SUBJECT: MILLSTONE POWER STATION, UNIT NO. 3 - ISSUANCE OF AMENDMENT
RE: SPENT FUEL POOL CRITICALITY (TAC NO. MD8251)

SAFETY EVALUATION BY THE OFFICE OF NUCLEAR REACTOR REGULATION

RELATED TO AMENDMENT NO. 248

MILLSTONE POWER STATION, UNIT NO. 3

Figure 3.9-3 Minimum Fuel Assembly Burnup and Decay Time Versus Nominal Initial Enrichment for Region 2 Storage Configuration

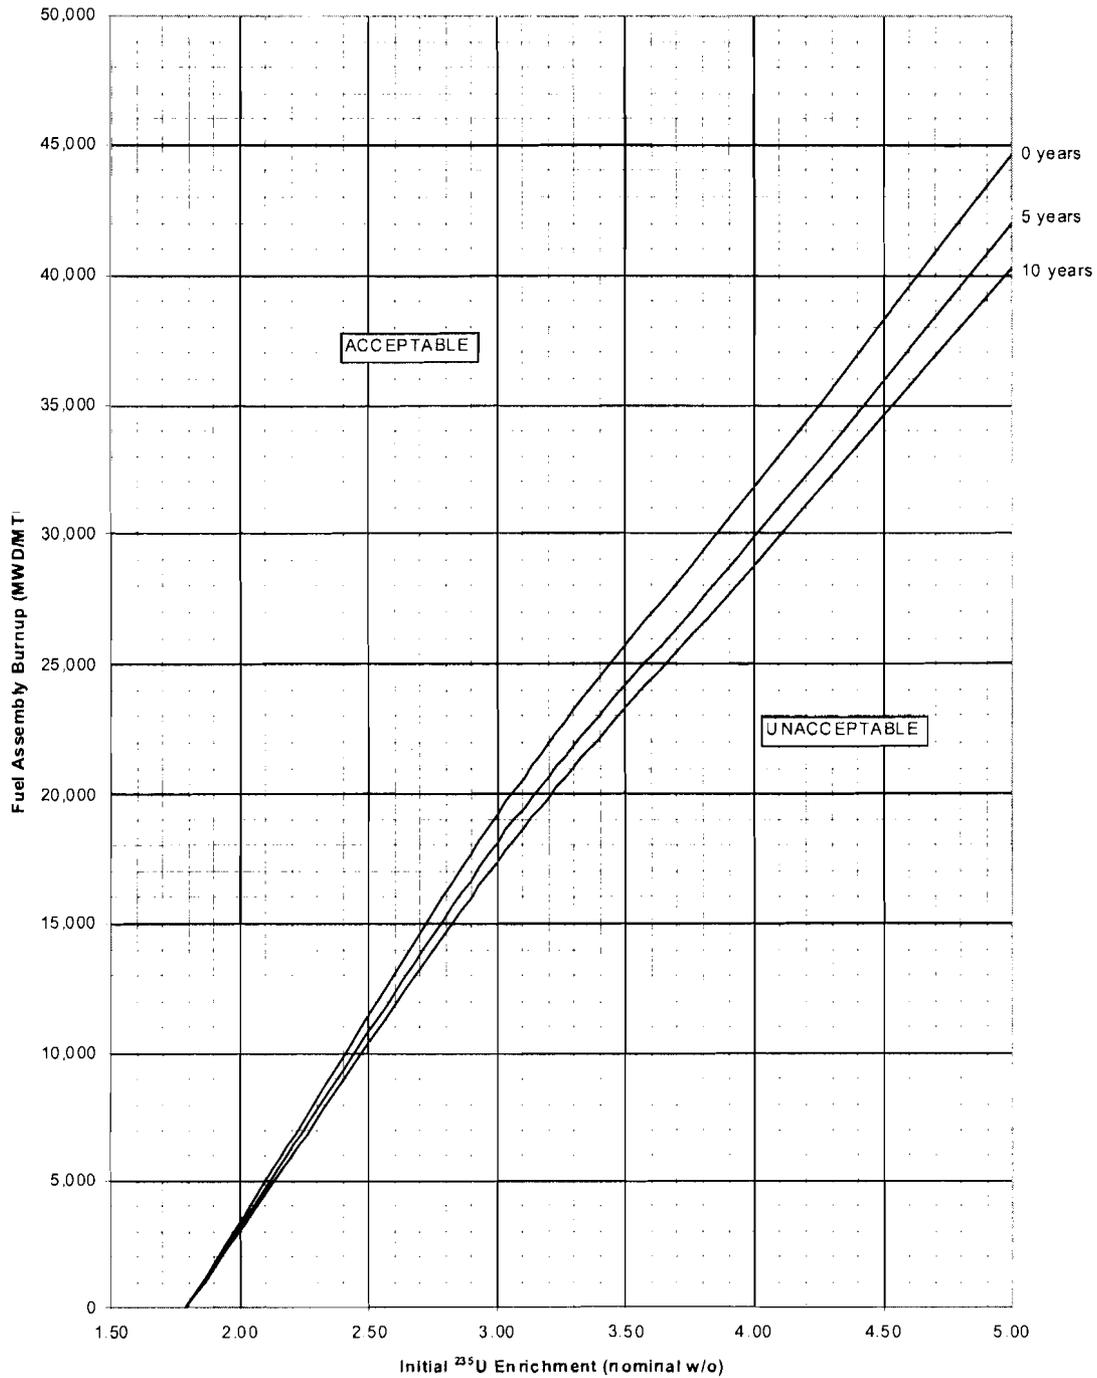
The Region 2 '4-out-of-4' storage configuration is a pattern of four fuel assemblies that have to meet the burnup and enrichment requirements of TS Figure 3.9-3. This storage configuration was reanalyzed in WCAP-16721-P. The analysis in WCAP-16721-P shows the current TS Figure 3.9-3 to be non-bounding for the updated core operating parameters, input, and assumptions. The licensee has proposed a revised TS Figure 3.9-3 that has more stringent burnup and enrichment loading requirements, and also takes credit for the decay of ^{241}Pu and the build-up of Americium-241 (^{241}Am). The revised Figure 3.9-3 is open to both pre-SPU and post-SPU discharged fuel assemblies. However, there are restrictions captured in a note to the figure. The note includes axial blanket restrictions on post-SPU discharged fuel assemblies. Only the first four fuel batches at MPS3 were non-blanketed, and those are prohibited from being stored in Region 2.

- The current non-blanketed fuel is prevented from being stored in Region 2 by a footnote to the revised TS Figure 3.9-3.
- The current non-blanketed fuel is prevented from being stored in Region 3 by the new TS Figure 3.9-5 because this figure is only applicable to post-SPU discharged fuel

- Both the revised TS Figure 3.9-3 and the new TS Figure 3.9-5 have footnotes that delineate the axial blankets that may be credited in determining acceptability for storage. Fuel assemblies that do not meet those requirements must be stored as non-blanketed.

NOTE: For assemblies from Post-Uprate (3650 Mwt) Cores, the nominal fuel enrichment of blankets must be ≤ 2.6 w/o U-235, and nominal blanket length must be at least 6 inches on both ends of the fuel. Fuel batches A, B, C, and D may not be stored in Region 2.

Figure 3.9-4 Minimum Fuel Assembly Burnup and Decay Time Versus Nominal Initial Enrichment for Region 3 Storage Configuration for Assemblies from Pre-Uprate (3411 Mwt) Cores

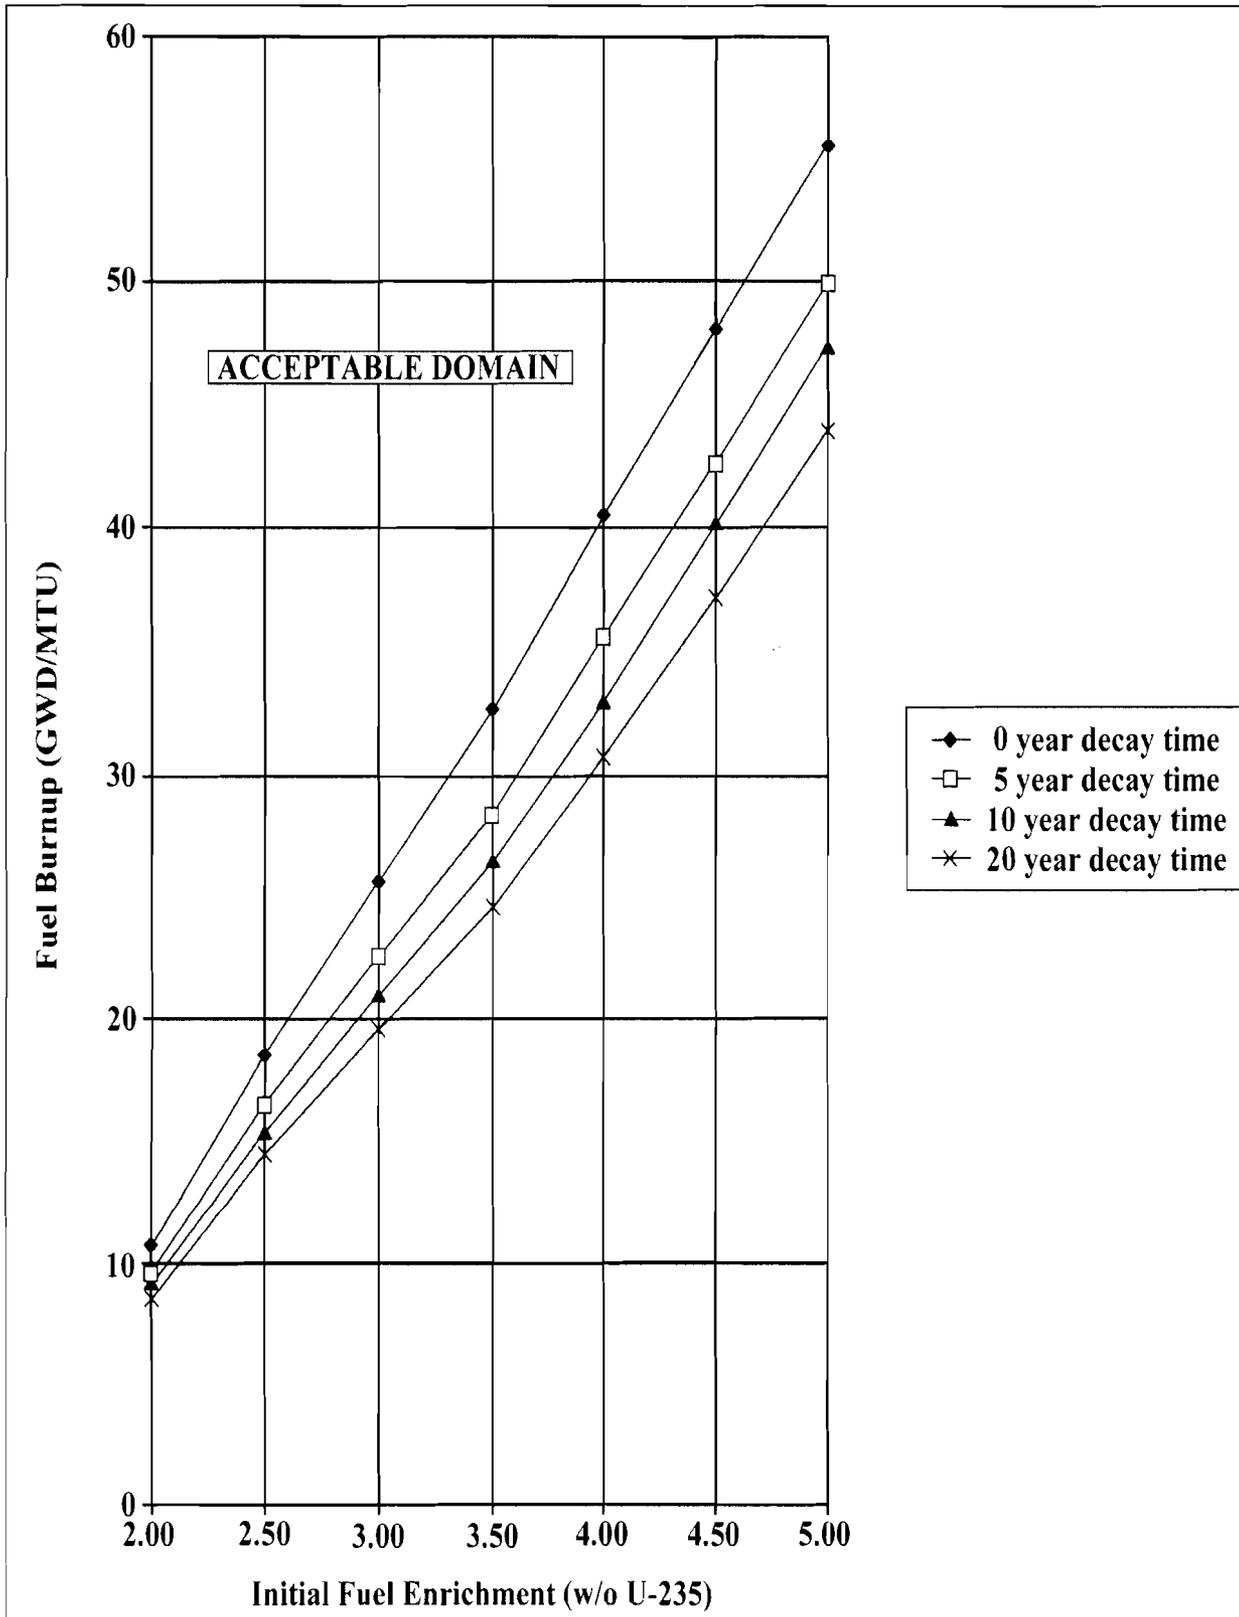
The Region 3 '4-out-of-4' storage configuration is a pattern of four fuel assemblies that have to meet the burnup and enrichment requirements of TS Figure 3.9-4. This storage configuration was reanalyzed in WCAP-16721-P. The analysis in WCAP-16721-P shows the current TS Figure 3.9-4 to be non-bounding for the updated core operating parameters, input, and assumptions. The licensee has proposed a change to the title of Figure 3.9-4 to limit its applicability to pre-SPU discharged fuel assemblies. To accommodate post-SPU discharged fuel assemblies in Region 3, the licensee has proposed adding TS Figure 3.9-5.

assemblies. The current non-blanketed fuel can be stored in Region 3 as long as it meets the requirements of the TS Figure 3.9-4.
